Amendment of the Bay-Delta Water Quality Control Plan's Compliance and Baseline Monitoring Program

Presented to the State Water Resources Control Board
By Stephen Ford (DWR) and Erwin Van Nieuwenhuysse (Reclamation)
October 27, 2004

Proposed Amendments to the 1995 Bay-Delta Plan's Monitoring Plan

Figure 3: Comparison of Hood and Greens Landing Monitoring Stations

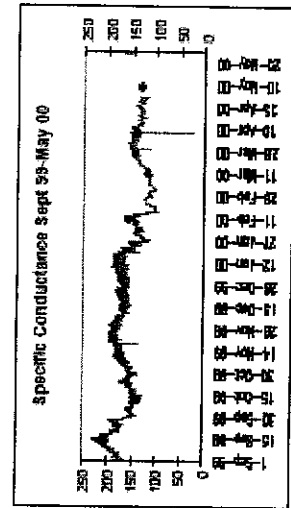
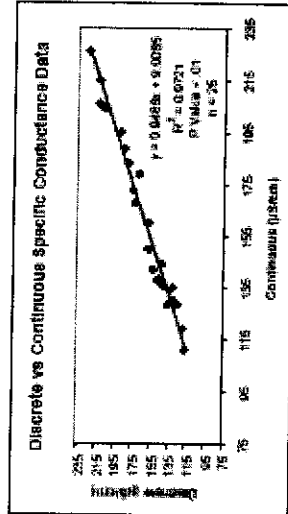
- 17 monitoring elements would remain unchanged
- 4 monitoring elements would remain operationally unchanged but would be identified with new station numbers
- 8 historically monitored elements would be reestablished
- 8 historically monitored elements would be removed
- 8 baseline monitoring elements would be added
- 2 baseline monitoring elements would be moved to consolidate two neighboring stations (Hood & Greens Landing) for greater sampling

efficiency. Comparisons of monitoring data from these two stations show no differences (Figure 3 of this document).

Figure 4: Proposed Revision of Figure 2 of the 1995 Bay-Delta Water Quality Control Plan

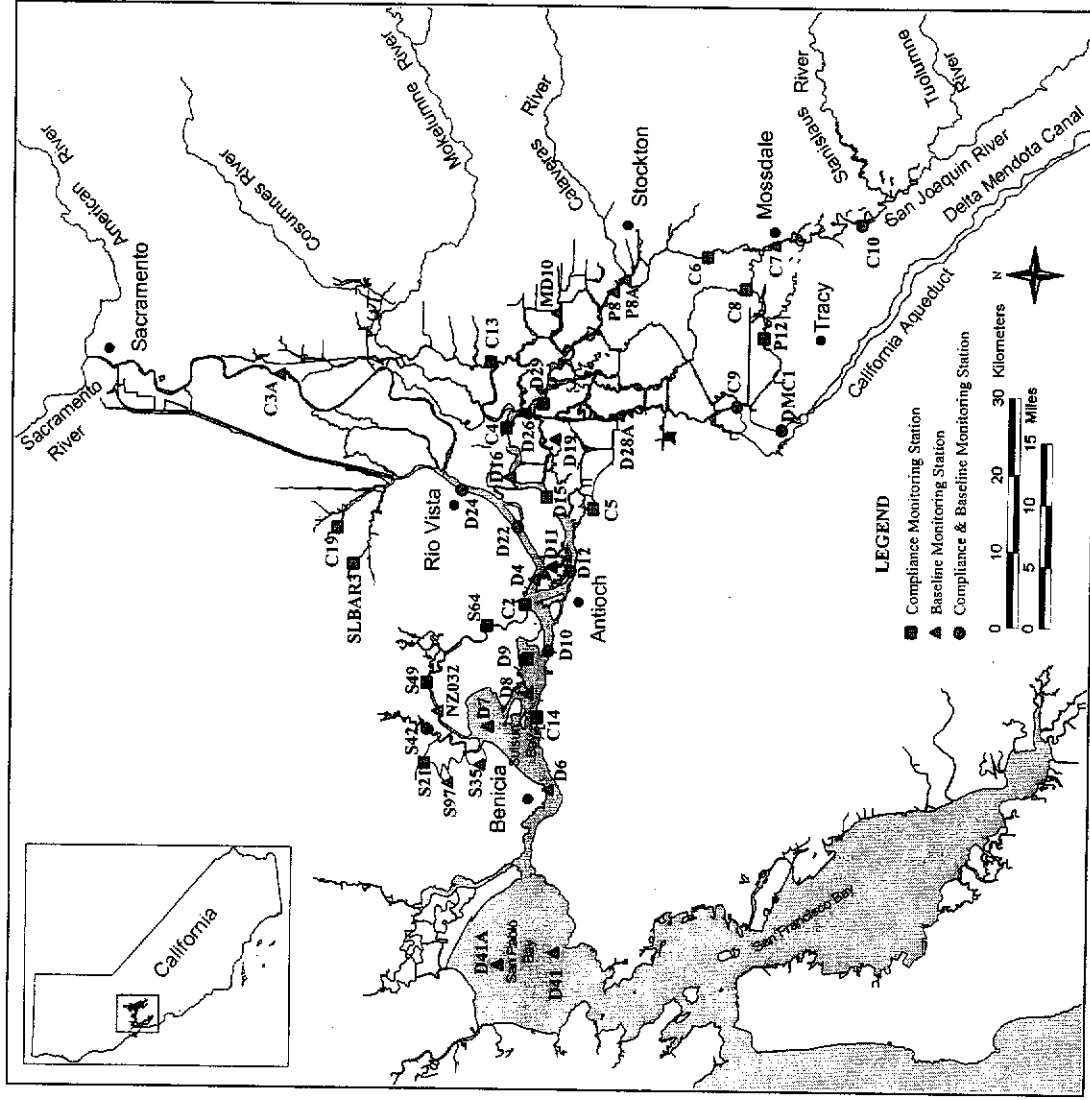
The amendment of Figure 2 of the Plan would reflect the previously proposed changes to the monitoring plan. Figure 4 of this document shows the proposed revision of the Plan's Figure 2.
